RESPONSE TO AUSTRALIAN ENERGY REGULATOR

Proposed Service Target Performance Incentive Scheme

30 October 2009

ENERGEX LIMITED ABN 40 078 849 055

Figure 1 – ENERGEX's understanding of methodology to calculate USAIDI targets

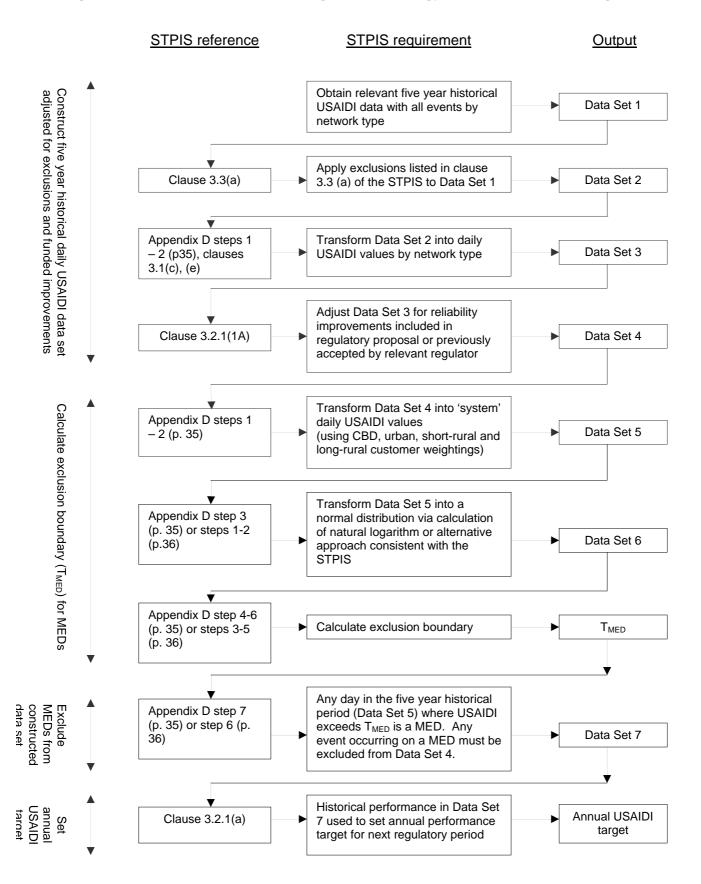
Secondly, in light of this statement, ENERGEX requests the AER confirm the correct application of the exclusion boundary and calculation of performance targets under the STPIS.

ENERGEX's understanding of the calculation STPIS performance targets under the proposed STPIS is outlined in Figure 1. ENERGEX requests that the AER confirm the general accuracy of this interpretation and proposes that such a flow diagram be included in the material accompanying the final STPIS.
